Re: The 66
4501 Central Ave. NE
Traffic Circulation Layout
Architect's Stamp 03-06-23 (K17-D123)

Based upon the information provided in your submittal received 04-07-23, the above referenced plan cannot be approved for Building Permit until the following comments are addressed:

SITE PLAN

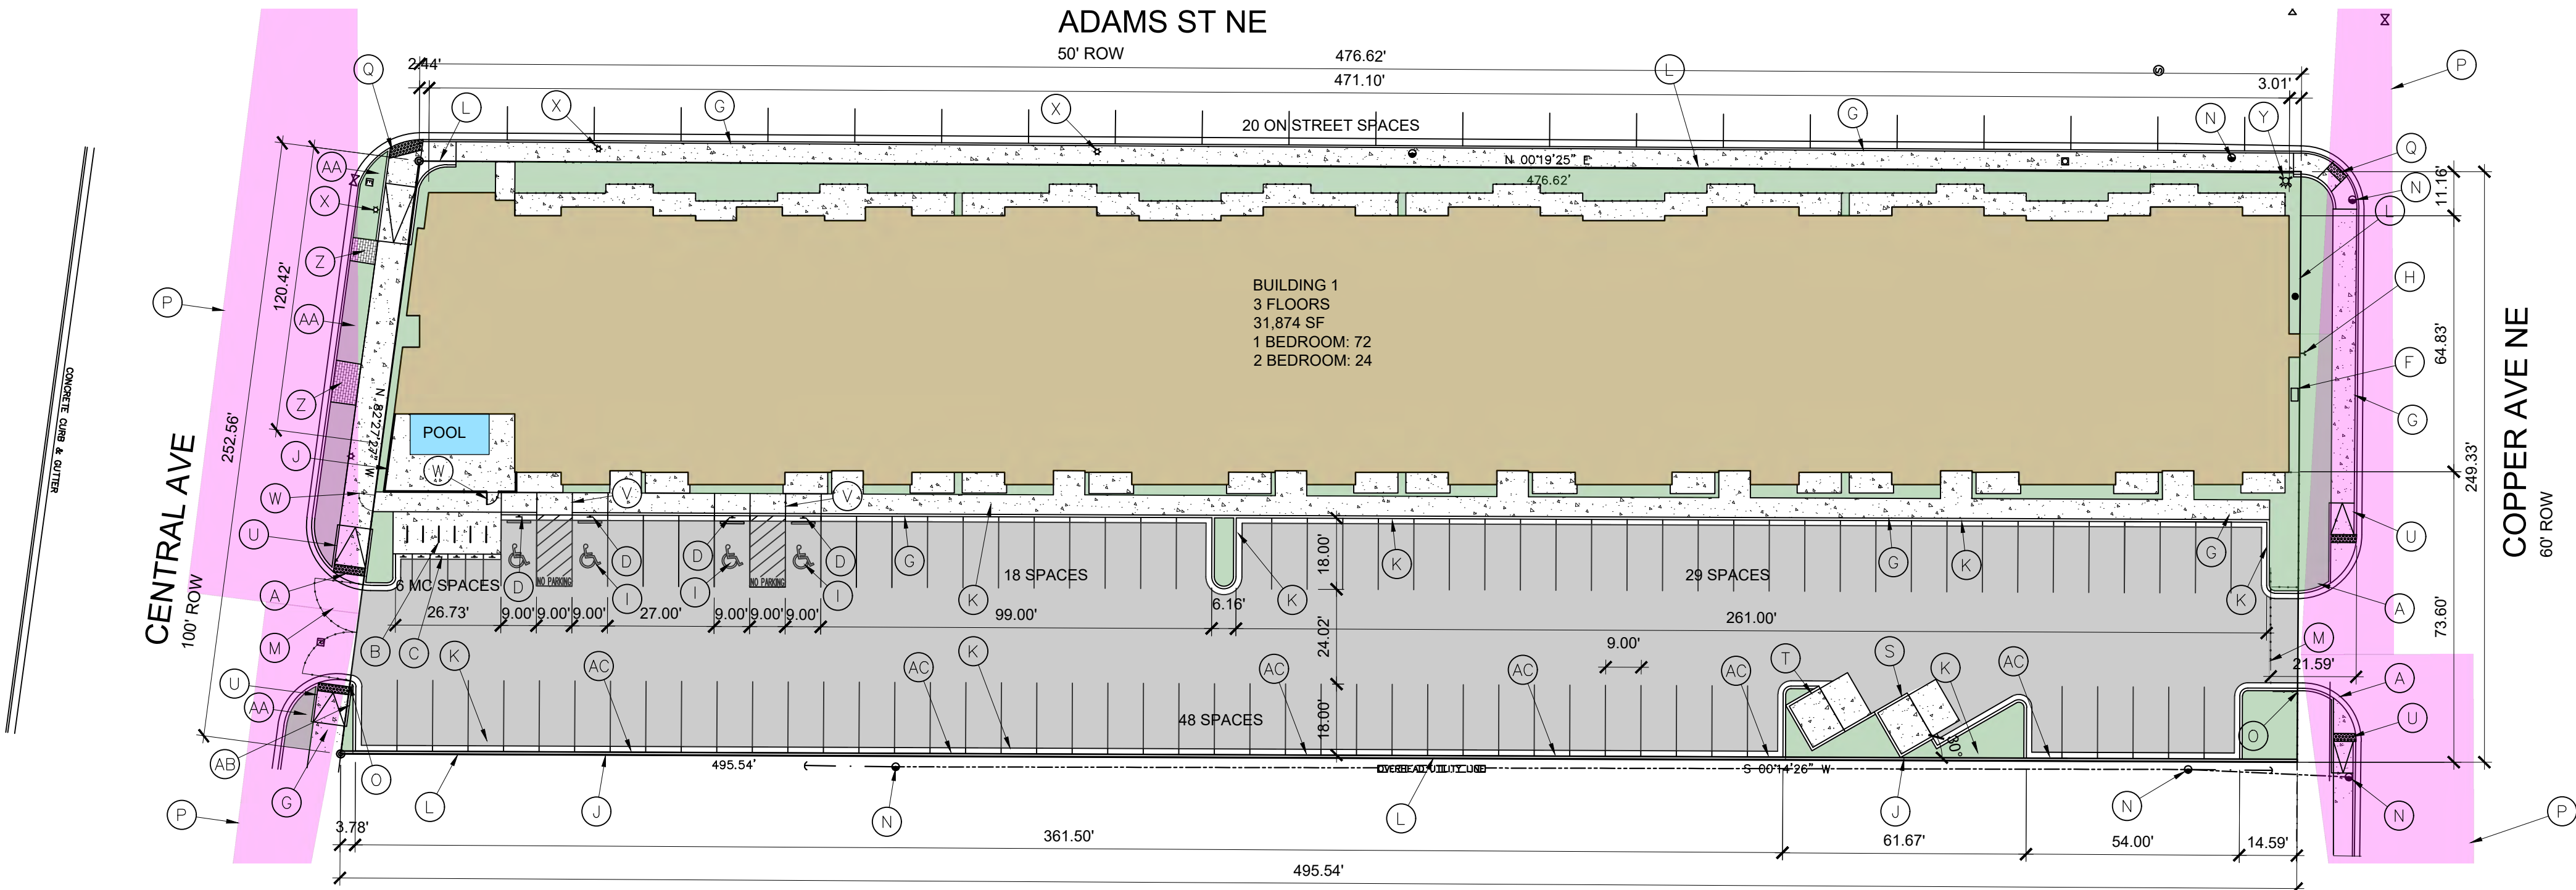
1. Identify all existing access easements and rights of way width dimensions.
2. Please show on the site plan the site accesses width off Central Ave and Copper Ave.
3. Maximum access width for arterial, collector, and local streets are as follows:

4. Keynote A: Provide the radius for the both proposed driveway accesses.
5. Provide the type of gate off Central Ave. and show on the site plan a setback allows at least one vehicle in the queue before the gate.
6. Provide turning around template for both site accesses.
7. Provide the dimensions for the on-street parking spaces.
8. Please show on the site plan a minimum 20ft. long no parking zone between the pedestrian crossing and the nearest on-street parking space.

9. Please revised the site plan, the number of the parking spaces at the east side of the site is 46.
10. Please show on the site plan a minimum 4 ft. wide ADA pathway around each obstacle on the public sidewalk off Adams St. and Copper Ave.

11. The pavement marking "MC" should be shown in the opposite direction for motorcycles entering the parking space.
12. All bicycle racks shall be designed according to the following guidelines:

16. Per the IDO, a 6 ft. wide ADA accessible pedestrian pathway is required from the public sidewalk to the building entrances. Please clearly show this pathway and provide details.

17. Per DPM, a 6 ft. wide ADA accessible pedestrian pathway is required from the ADA parking stall access aisles to the building entrances. Please clearly show this pathway and provide details.

18. ADA accessible pedestrian pathway should not be placed behind parking space or adjacent to a vehicular way. Vehicle and pedestrian/wheel chair conflicts should be avoided as much as possible.

19. Provide a copy of Fire Marshal approval.
20. Show on the site plan the Intersection clear site triangle at the corner of Central and Adams St. and at the corner of Adams St. and Copper Ave.

21. It is not apparent what type of pavement surface is being proposed. A hard driving surface will be required as part of this proposed project for parking area and drive aisles.
22. Please specify the City Standard Drawing Number when applicable.
23. Add a note stating "All broken or cracked sidewalk must be replaced with sidewalk and curb & gutter." A build note must be provided referring to the appropriate City Standard drawing.
24. Please provide a letter of response for all comments given.

BIKE PARKING

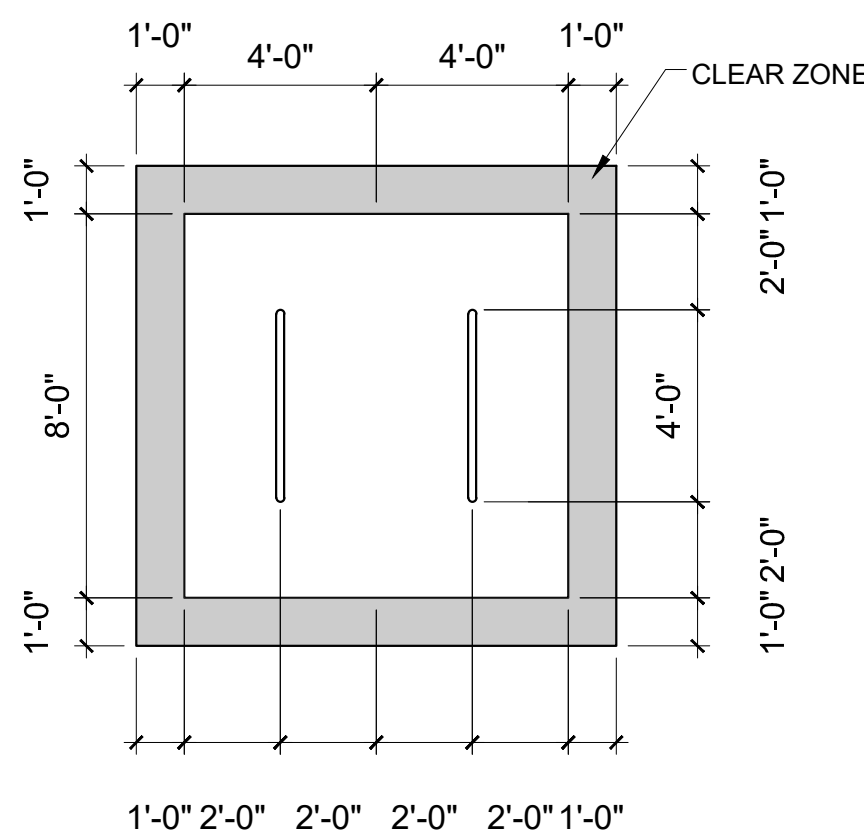
- a. The rack shall be a minimum 30 inches tall and 18 inches wide.
 - b. The bicycle frame shall be supported horizontally at two or more places. Comb/toaster racks are not allowed.

- c. The rack shall be designed to support the bicycle in an upright position. See the IDO for additional information.
 - d. The rack allows varying bicycle frame sizes and styles to be attached.

- e. The user is not required to lift the bicycle onto the bicycle rack.
 - f. Each bicycle parking space is accessible without moving another bicycle.

13. Bicycle racks shall be sturdy and anchored to a concrete pad.
14. A 1-foot clear zone around the bicycle parking stall shall be provided.
15. Bicycle parking spaces shall be at least 6 feet long and 2 feet wide.
